Central Nebraska Veterans Home

Addendum 1

Date Issued: November 20, 2015
Bid Date: December 17, 2015

1 ROOF DETAIL - CANOPY PARAPET

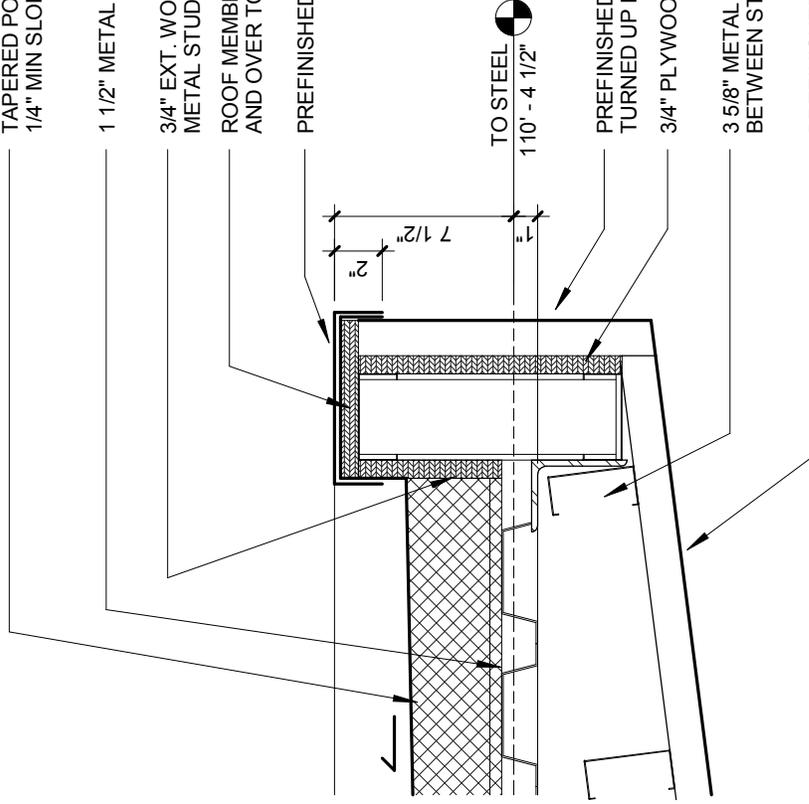
- Addendum 1 - 30 Sheet A7.13 – Wall Sections – Building J – Veterans Home Center**
At Detail 14/A7.13, replace with revised detail on attached sketch SKA1.

PREFINISHED METAL SOFFIT (TYPE 2)
TURNED UP FOR FASCIA

PREFINISHED METAL SOFFIT (TYPE 2)

ROOF DETAIL - CANOPY PARAPET

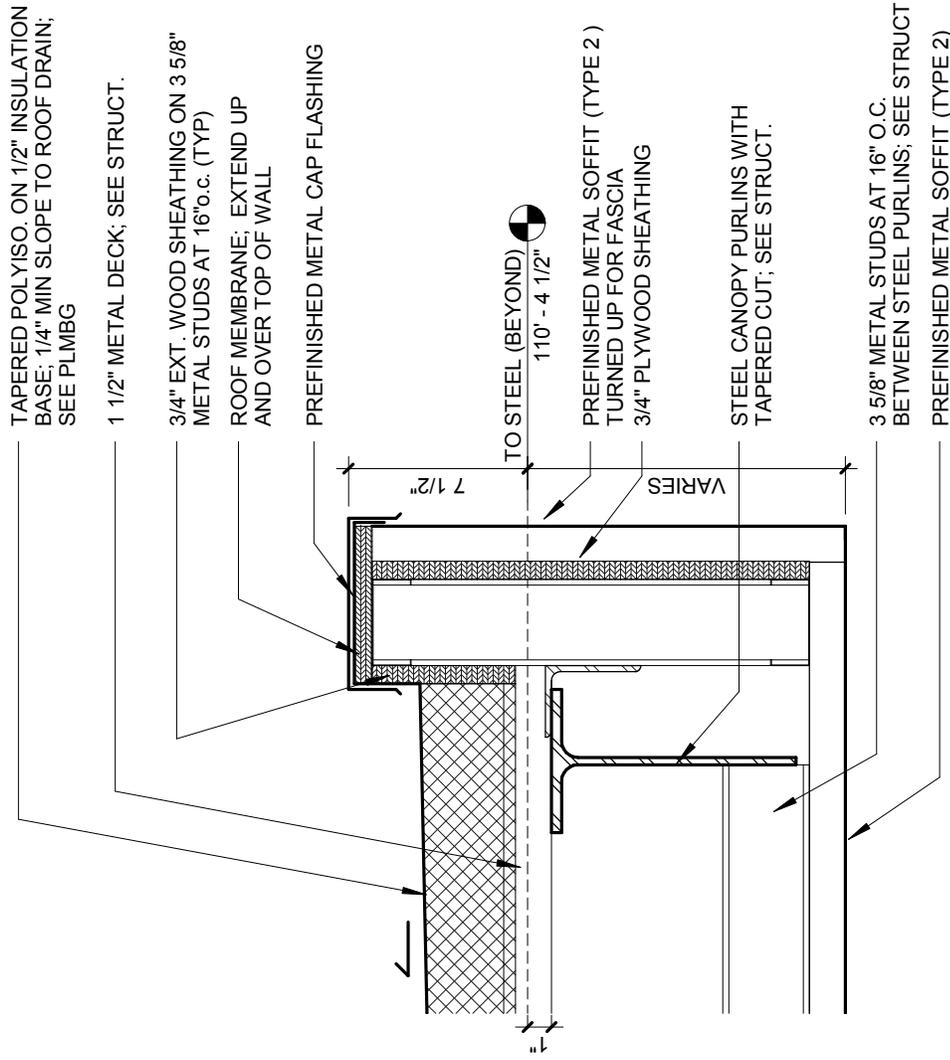
- Addendum 1 - 31 Sheet A7.13 – Wall Sections – Building J – Veterans Home Center**
At Detail 15/A7.13, replace with revised detail on attached sketch SKA2.
